Site Plan Review Committee (SPRC)
Staff Report for
1840 Wilson Blvd. – NSTA Site

NSTA Site (SP #478)
1840 Wilson Blvd. (1805 Clarendon Blvd.)
(RPC#s 17-011-057, -056)

Rhodes Street Section looking North (Left); Rhodes Street Sidewalk Section (Right)

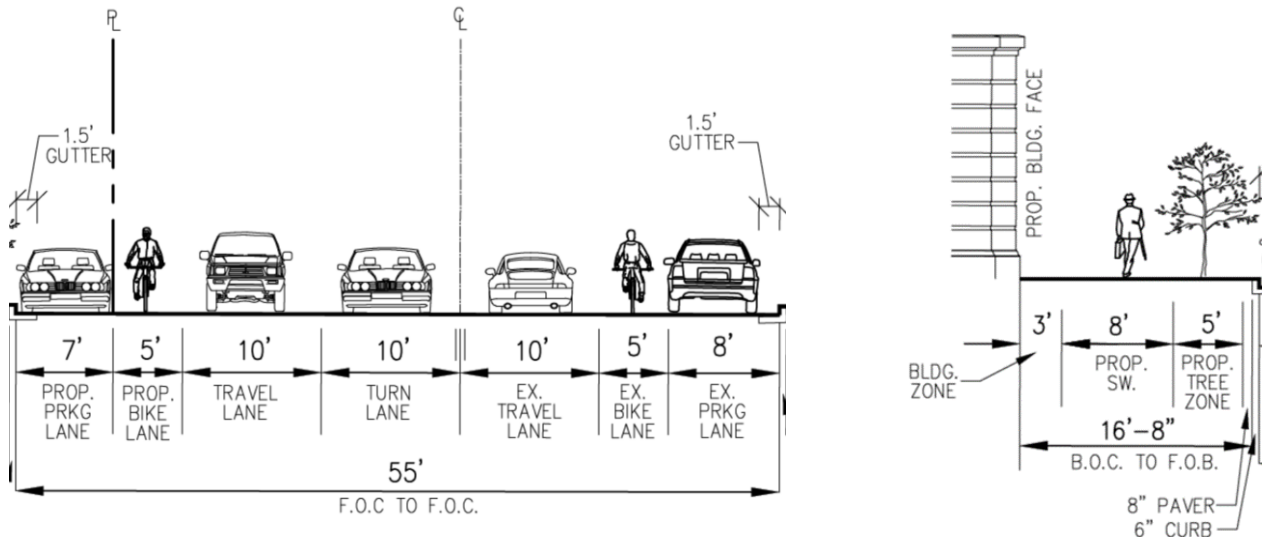
In the site vicinity, North Rhodes Street meets parts of this typology. While it is in a medium to high densely populated and travel area and has transit facilities nearby, it has limited bicycle facilities adjacent to the site. The existing lane configurations will be maintained though the curb-to-curb width will be reduced from 55.7 feet to 55 feet. Within the curb-to-curb width the applicant is proposing a new southbound bike lane previously treated as a shared-use lane with a southbound motor vehicle lane. It’s sidewalk is an 8’ width with no tree pits or landscape buffer but there are numerous sign posts. There are no driveways along North Rhodes Street adjacent to site and none are proposed by the applicant. The street sections proposed by this project show to increase the total streetscape width to 16’8”, including 5’ tree pits with an 8” step-off area, 8’ clear sidewalk, and 3’ shy zone. The R-B Corridor streetscape plans call for a 16’8” total streetscape including 5’x8’ (or larger) tree pits, which the applicant is meeting. The proposed sections are as shown below.

Clarendon Blvd Street Section looking East (Left); Clarendon Blvd Sidewalk Section (Right)

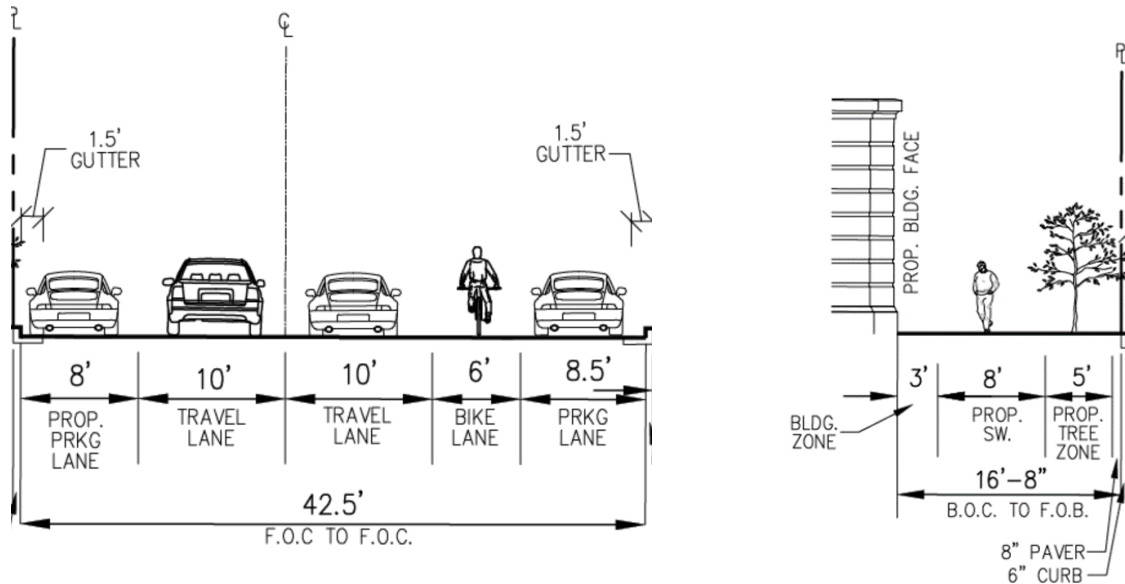
In the site vicinity, Clarendon Boulevard fits this typology as it serves a densely populated and highly traveled area with both transit and bicycle facilities provided within the street right-of-way. The existing lane configurations will be maintained though the curb-to-curb width will be reduced from 47.2 feet to 42.5 feet. At the intersection with North Rhodes Street the applicant proposes a curb extension. Clarendon Boulevard’s sidewalk along the site’s frontage vary in width from a suitable width (16’) to barely adequate (6’). Along the site’s frontage on Clarendon Boulevard there are three existing driveways serving the existing surface parking lot, loading dock, and alley. The street sections proposed by this project show to increase the total streetscape width to 16’8”, including 5’ tree pits with an 8” step-off area, 8’ clear sidewalk, and a 3’ shy zone. The applicant is proposing to remove two existing driveways serving the surface parking lot and loading dock and will maintain the alley driveway. The R-B Corridor streetscape plans call for a 16’8” total streetscape including

5'x8' (or larger) tree pits, which the applicant is meeting. The proposed sections are as shown below.

2 ZA SITE SECTION RHODES - 100
A-01.01 SCALE: 1" = 100'-0"

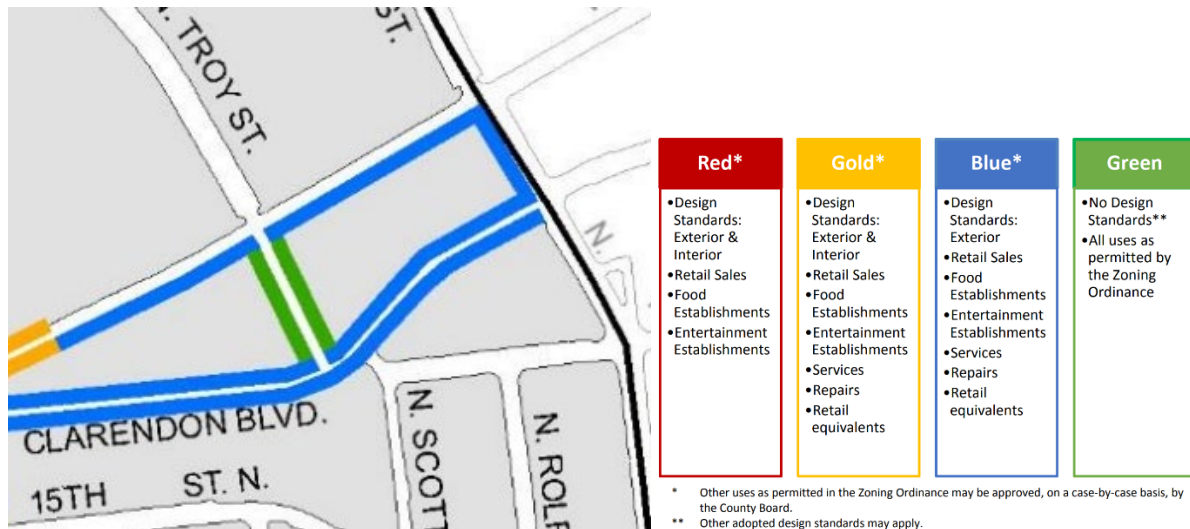
Building Height and Massing: The applicant is proposing a 7-story building, with building stepbacks at the 6-story level along all sides of the building and stepbacks at the second story along the north and south sides of the building. The RCUDS recommends a 5-story building, 55-foot tall, at this location. The RCUDS recommends flexibility for building heights to “accommodate affordable housing, community facilities, special design considerations, and/or new streets.” Moreover, the existing approved, but unconstructed office approval is permitted up to 6-stories.
